Subject: Class 1 Permit Modification Request Requiring Prior Approval for Treatment in Containers at TA-54-0412 for the Los Alamos National Laboratory Hazardous Waste Facility Permit, EPA ID No. NM0890010515

April 2021 EM2021-0037

Class 1 Permit Modification Request Requiring Prior Approval for Treatment of Hazardous Waste at TA-54-0412 for Los Alamos National Laboratory Hazardous Waste Facility Permit, EPA ID No. NM0890010515

Figure G.6-1: Technical Area 54, Area G, Pad 1 Outdoor Container Storage/Treatment Unit Grid Sampling Locations

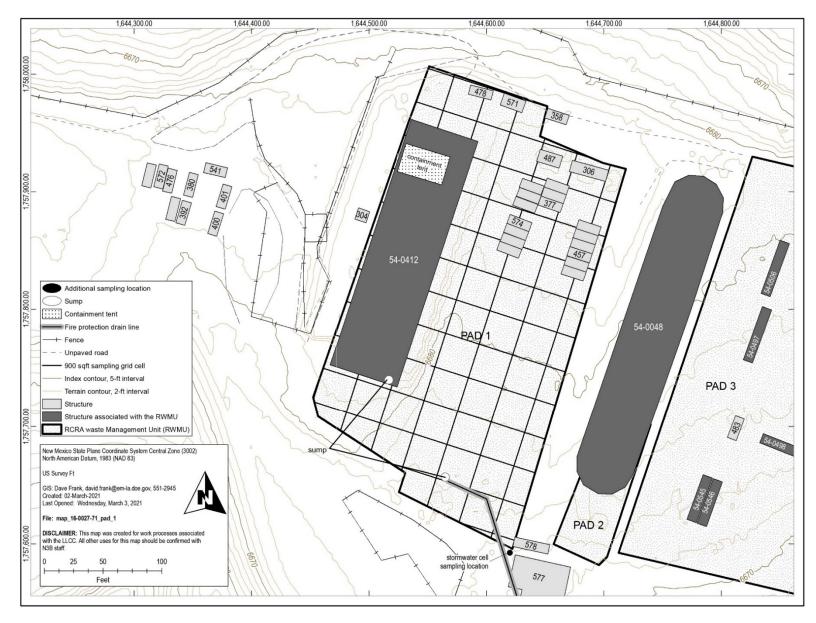
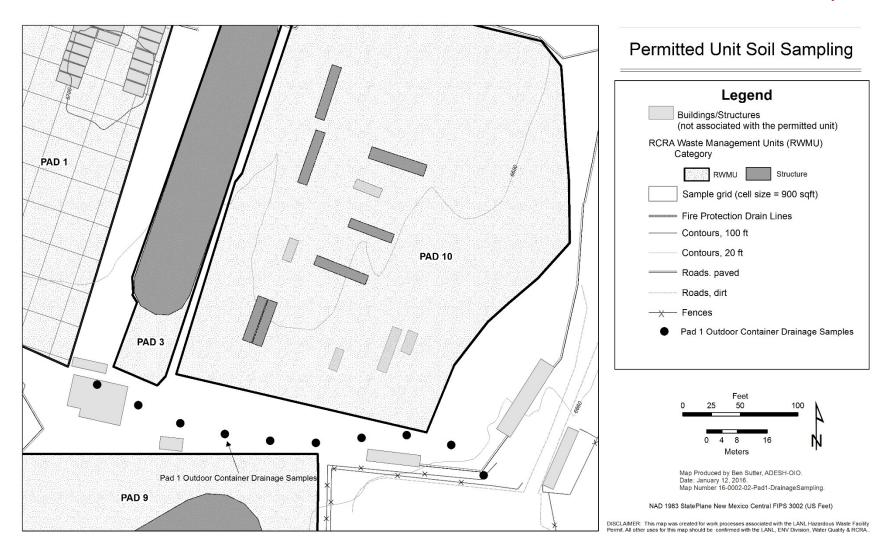
Throughout Attachment G.6, changes have been made to reflect that the unit will be utilized for treatment as well as storage of waste. Figure G.6-1, "Technical Area 54, Area G, Pad 1, Outdoor Container Storage Unit Grid Sampling and Additional Sampling Locations," was also revised to reflect that it is a storage and treatment unit and to show the location of the pre-engineered containment tent.

Figure 27: Technical Area 54, Area G, Container Storage/Treatment Units

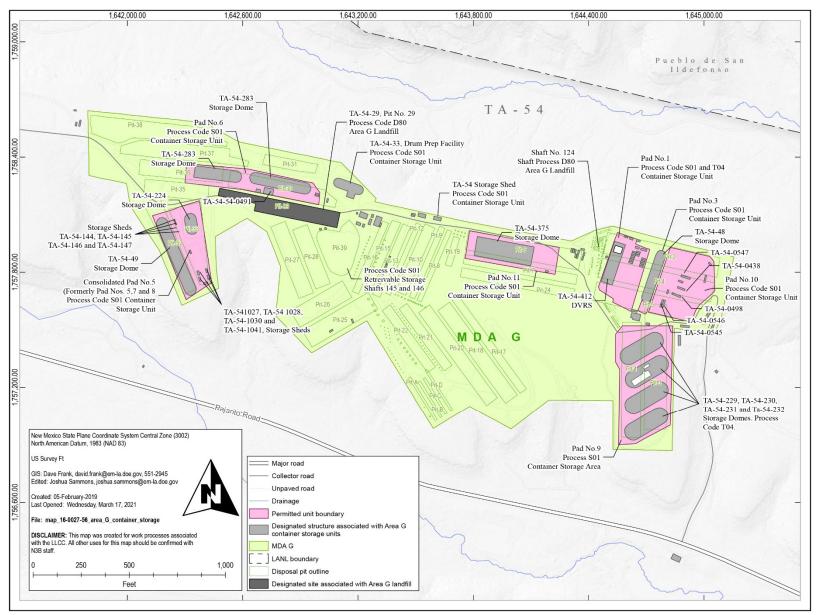
Waste treatment, storage, and repackaging are performed in a pre-engineered containment tent adjacent to the primary confinement structure located in the northwest bay of building 412 (Attachment N, Figure 27). The containment tent measures approximately 30 ft long by 27 ft wide by 15 ft high. The containment tent is equipped with a HEPA filtration system and a fire-detection system. Additional emergency and safety equipment for building 412 are listed in Attachment D, Contingency Plan. Attached to the containment tent are a radiological buffer area (RBA), dress-out room, and control room. The RBA measures 15 ft long by 10 ft wide. The RBA entrance allows safe transport of containers into the containment tent. Waste-handling activities do not take place within the dress-out room or the control room. The dress-out room measures approximately 10 ft wide by 20 ft long. The control room measures approximately 10 ft wide by 17 ft long.

Figure 29: TA-54, Area G, Pad 1

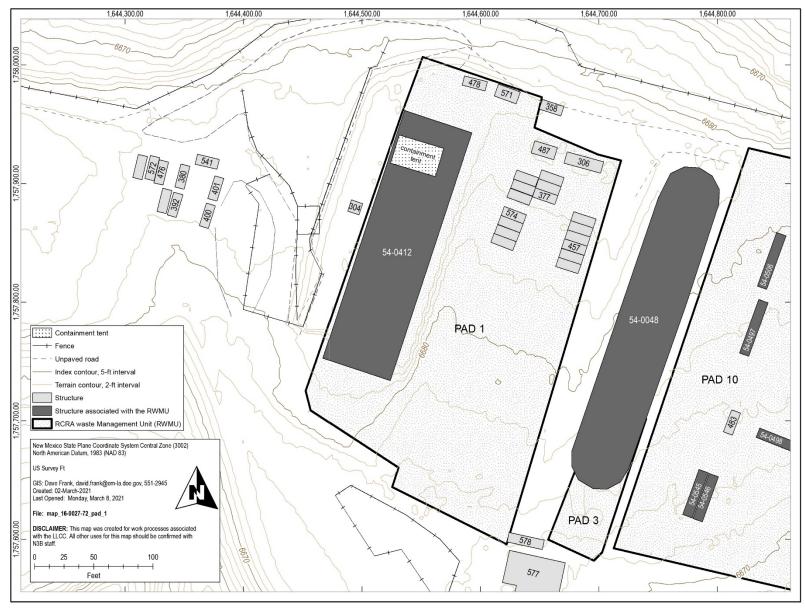
The 4 to 6 inch thick asphalt pad is approximately 358 feet long and 213 feet wide. TA-54-412 is located on the pad in the northeastern portion of Area G (*see* Figure 29 in Attachment N (*Figures*)).

TA-54-412 (*see* Figure 29 in Attachment N (*Figures*)) is a one story building that is approximately 220 feet long by 60 feet wide $(13,200 \text{ ft}^2)$. It consists of two structures, an internal primary confinement structure that houses the DVRS processing operations and an
